ADDENDUM NO. 1

February 16, 2024

Yorktown High School – Addition and Renovations 1100 South Tiger Drive Yorktown, IN, 47396

ADDENDUM

FIRST FLOOR PLAN - UNIT B

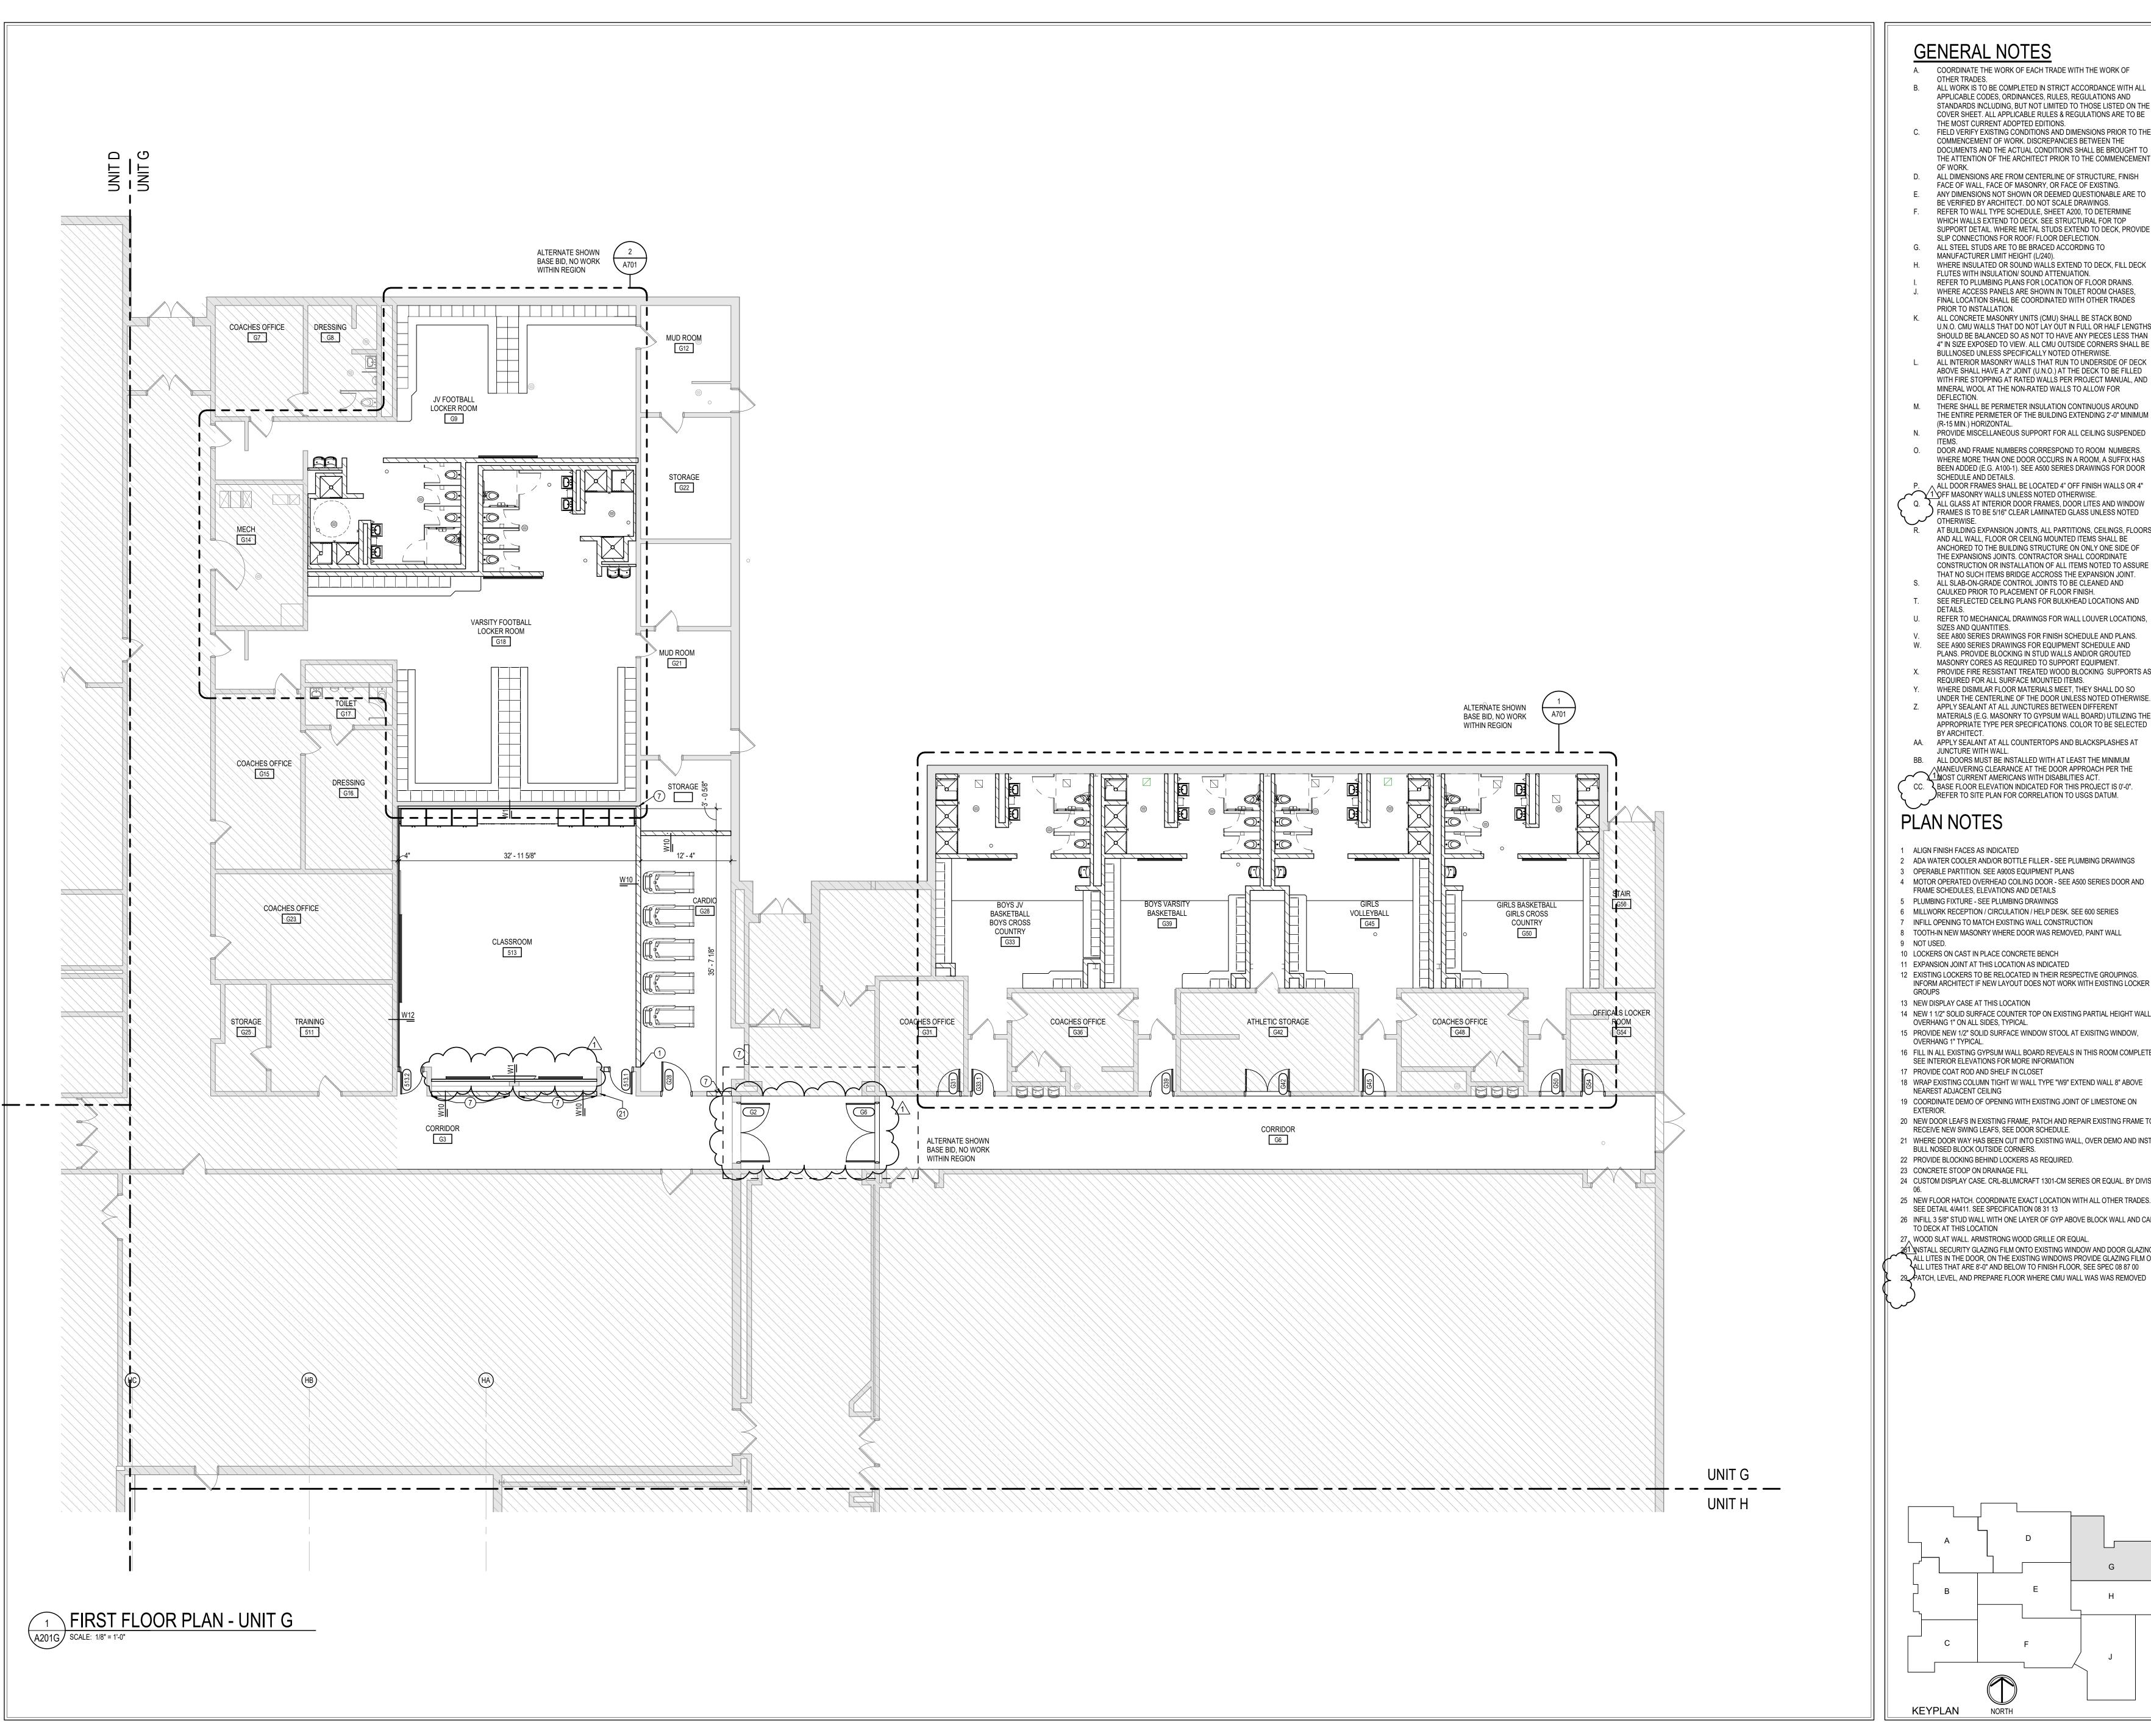
3.10 <u>A201B – FIRST FLOOR PLAN – UNIT B</u>

- A. Add Plan Note #28 INSTALL SECURITY GLAZING FILM ONTO EXISTING WINDOW AND DOOR GLAZING, ALL LITES IN THE DOOR, ON THE EXISTING WINDOWS PROVIDE GLAZING FILM ON ALL LITES THAT ARE 8'-0" AND BELOW TO FINISH FLOOR, SEE SPEC 08 87 00.
- B. Modify Door 100.2 to be **3'-0" double door.** See door schedule for additional information.

A201G PROJECT NUMBER

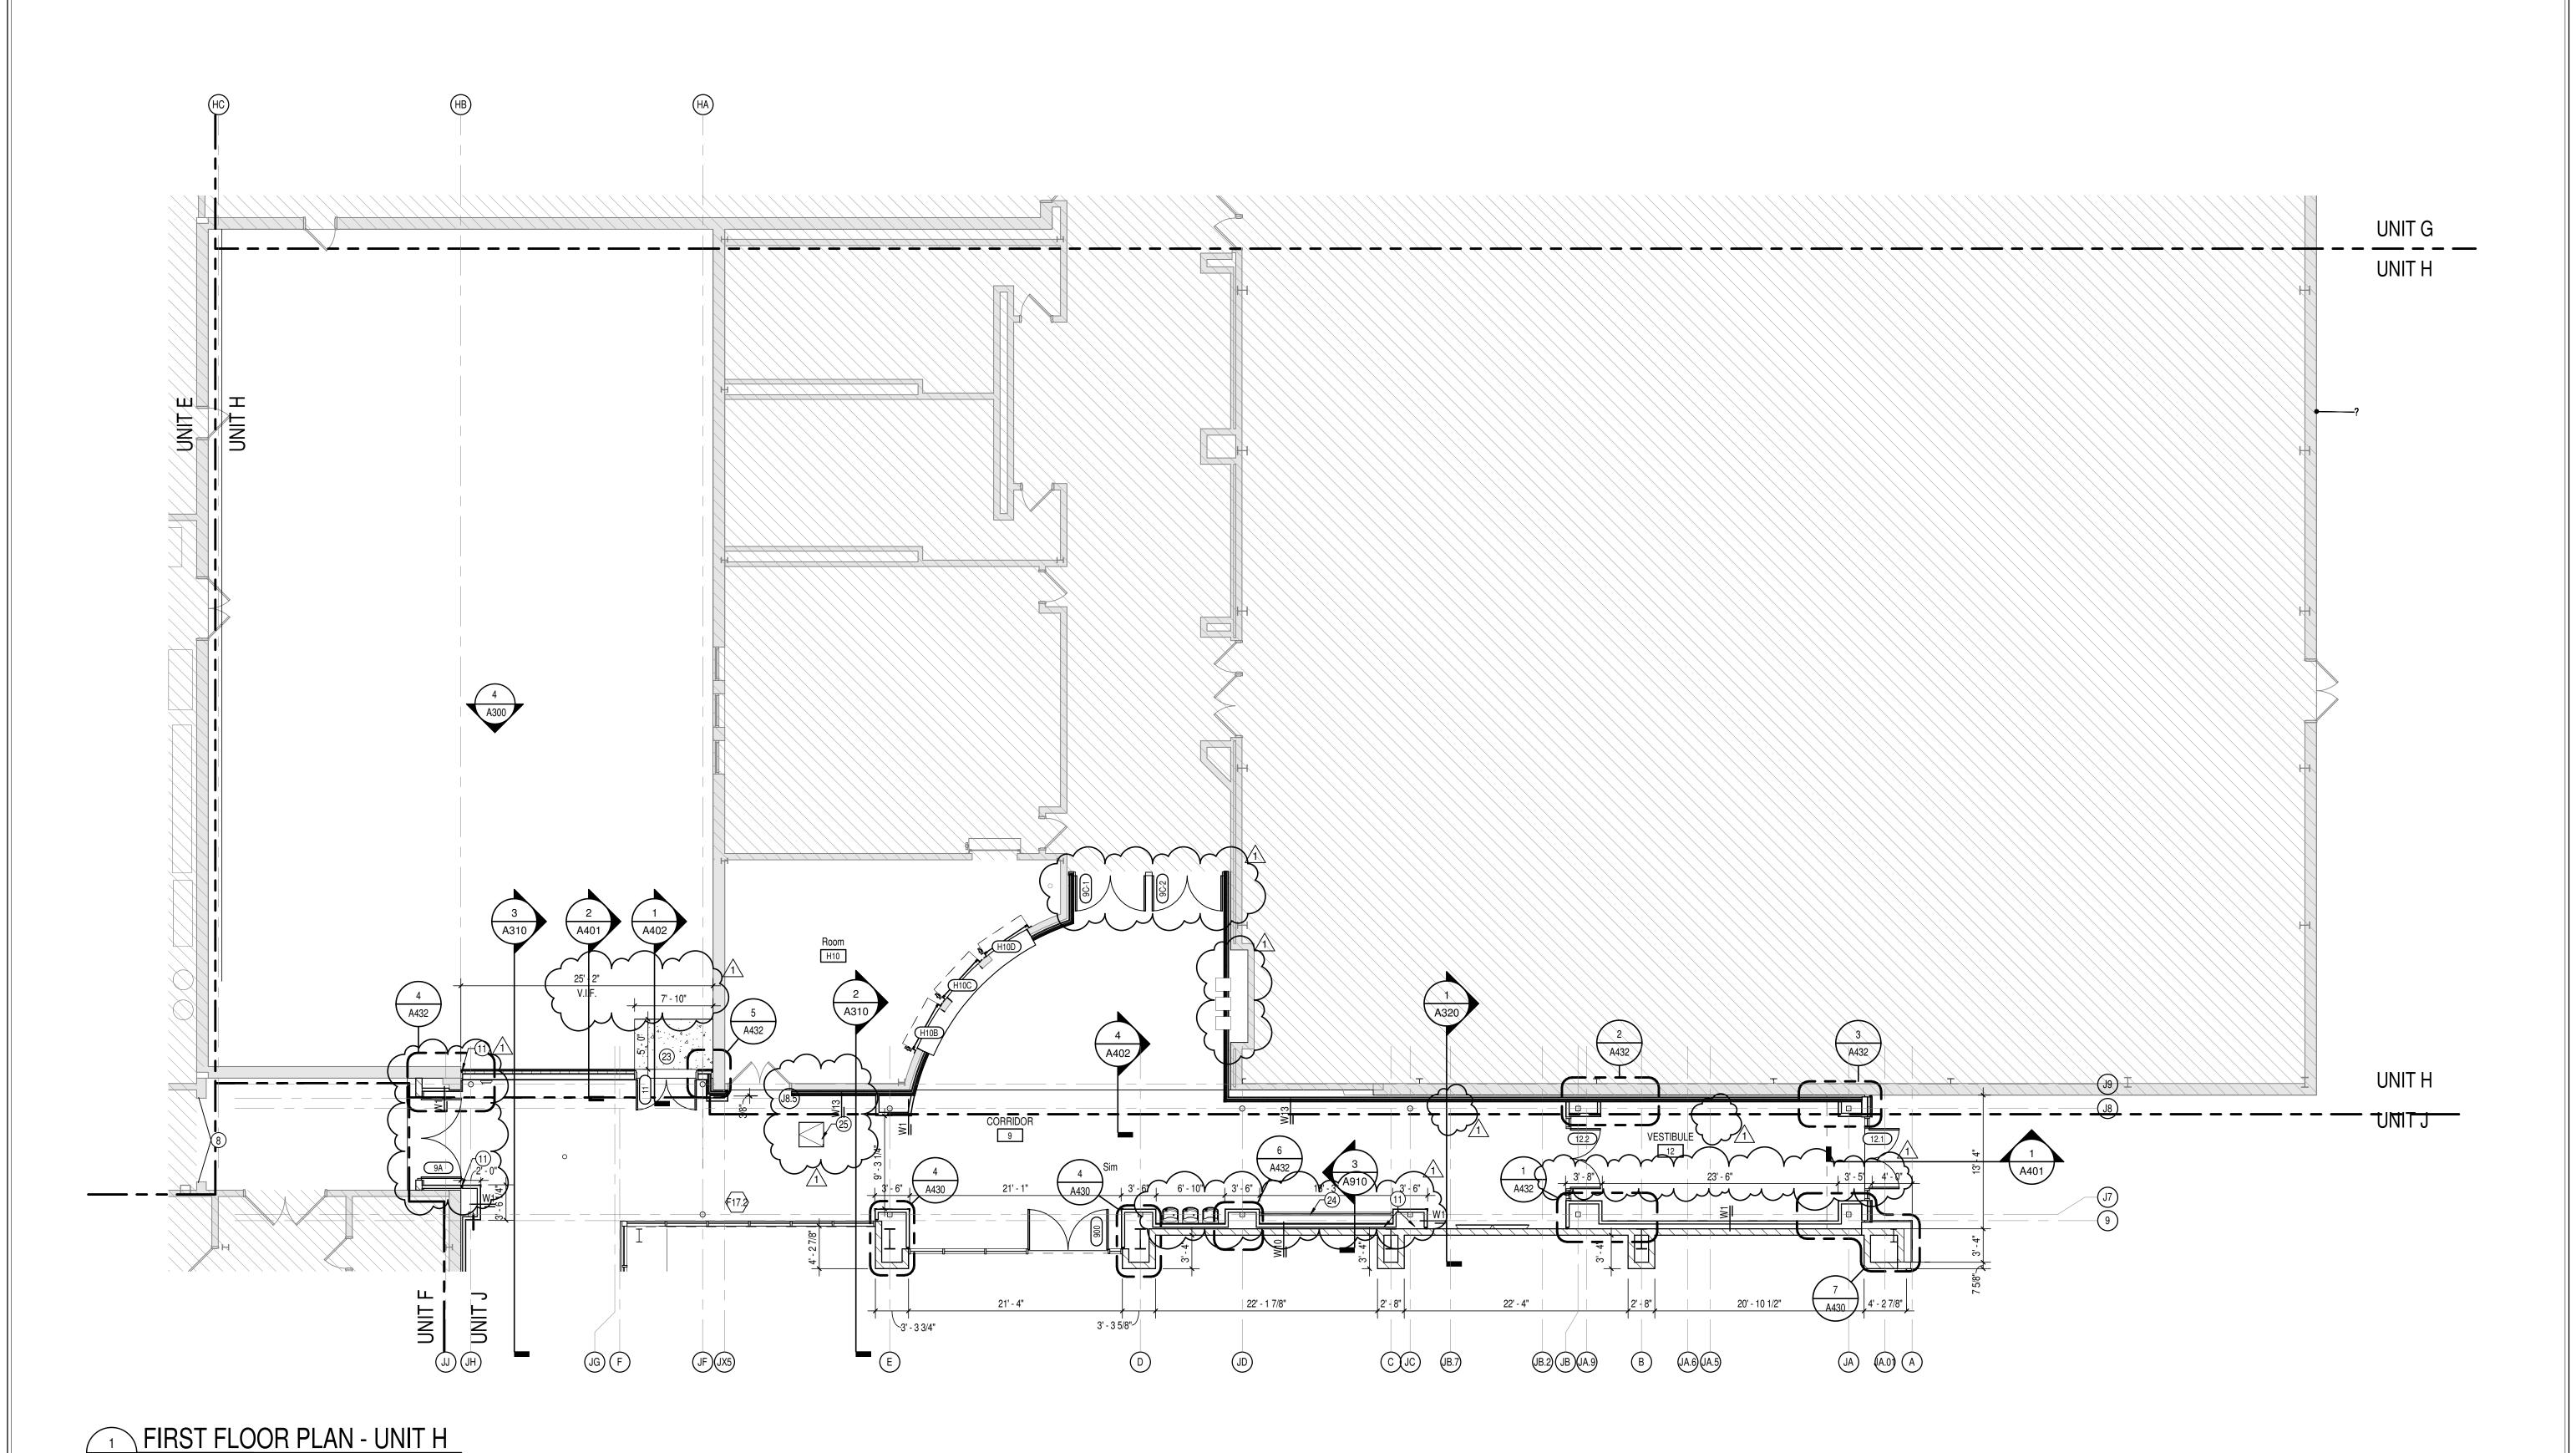
3.11 A201G – FIRST FLOOR PLAN – UNIT G

- A. Revise opening on classroom side of Classroom 513. Remove CMU to match existing opening and fur out existing wall in Classroom 513 with wall type **W1.**
- B. Indicate additional area of Alternate Bid.

DRAWING TITLE: FIRST FLOOR PLAN - UNIT H

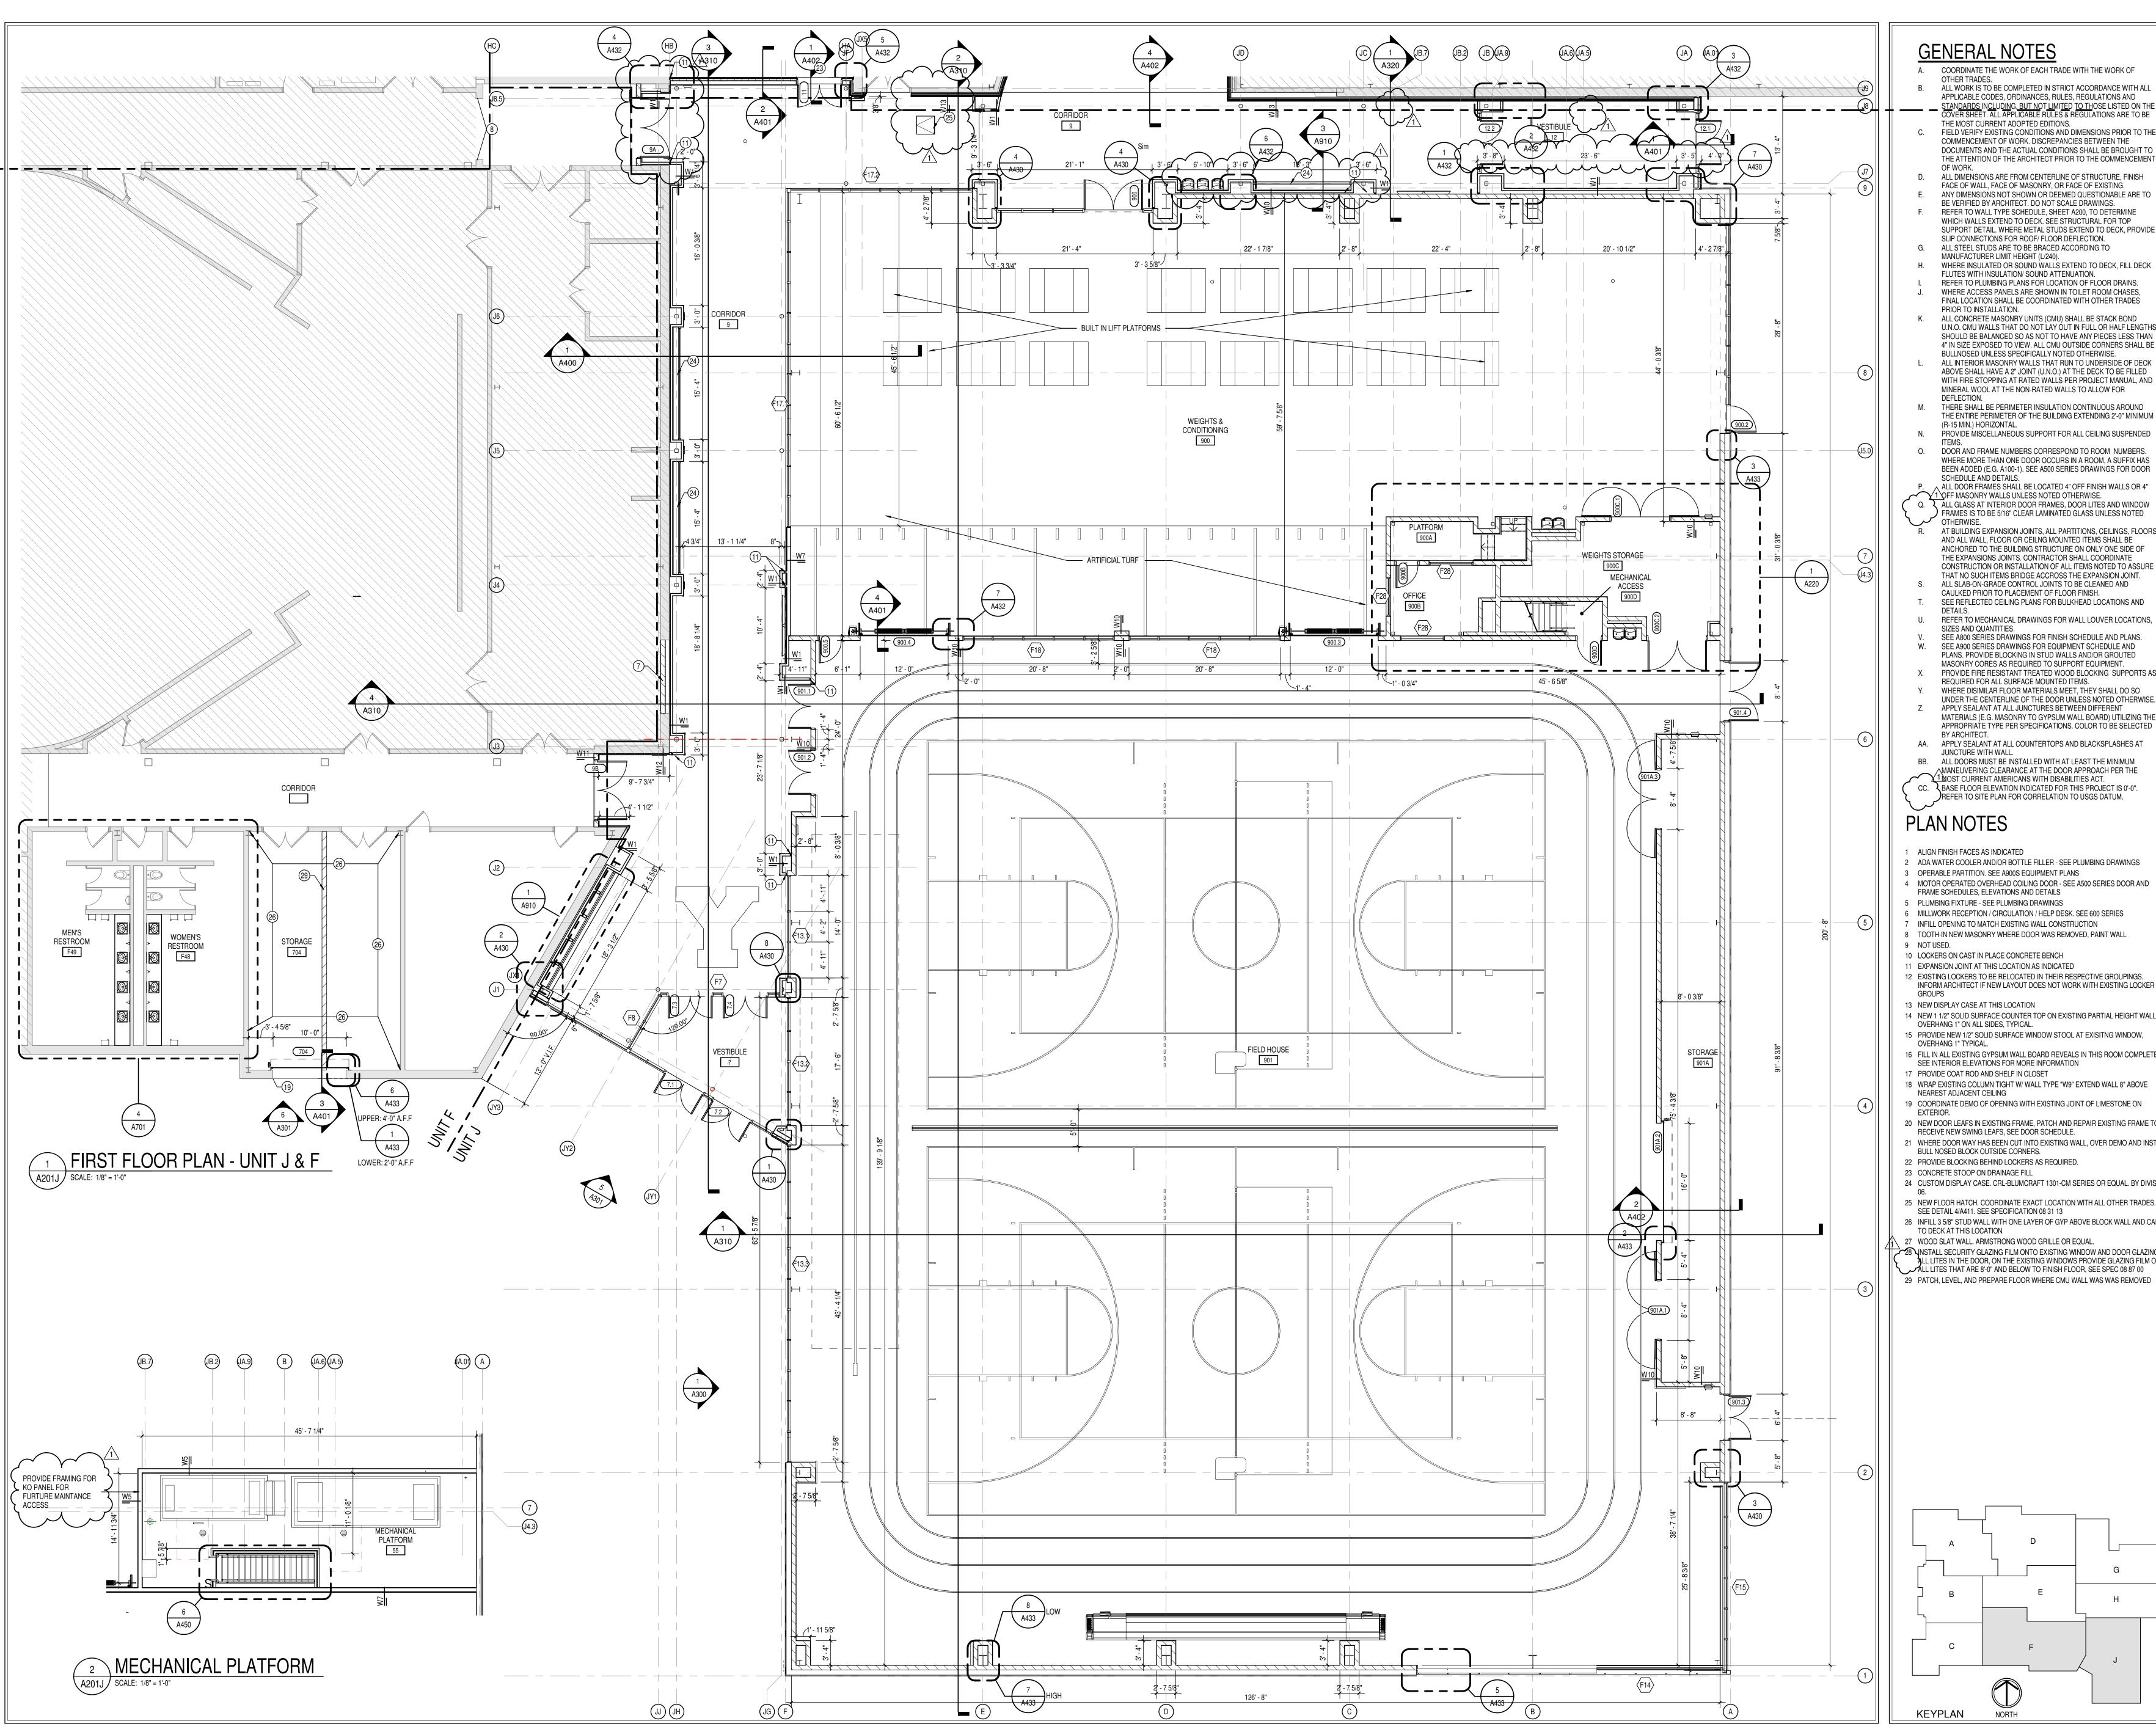
3.12 <u>A201H – FIRST FLOOR PLAN – UNIT H</u>

- A. Omit Plan Note #9 along Corridor 9 and Vestibule 12.
- B. Revise Plan Note #9 to read: **NOT USED.**
- C. Revise location of drinking fountains and place them where the 6'-6" display case was located.
- D. Tag doors 9C-1 and 9C-2.
- E. Replace doors H10B, H10C, and H10D.
- F. Relocate floor hatch door in Corridor 9 to coordinate with consultants.
- G. Provide dimensions for clarity between buildings.

H. Revise layout and fur out wall around door 9A.
